# **MINOR VARIANCE REPORT**

# APPLICATION: A/020/2025

A/020/2025 - 9 Southaven Place (West District) (OP Designation: Medium Density Residential)

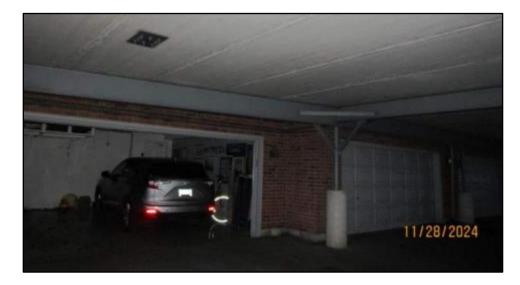
The proposed hot tub will be located at the inside corner of the deck, approximately 0.6 m from the patio doors accessing the deck. The proposed hot tub is 0.806 m tall and would be minimally visible on the deck when observed from the park.

The applicant also provided a structural adequacy for hot tub certificate prepared by a professional engineer which indicates that the existing hollow core slab deck, supported by a steel beam is capable to carry a hot tun with maximum operational weight of 4,000 lb and size of 8 ft by 8 ft over the steel beam.
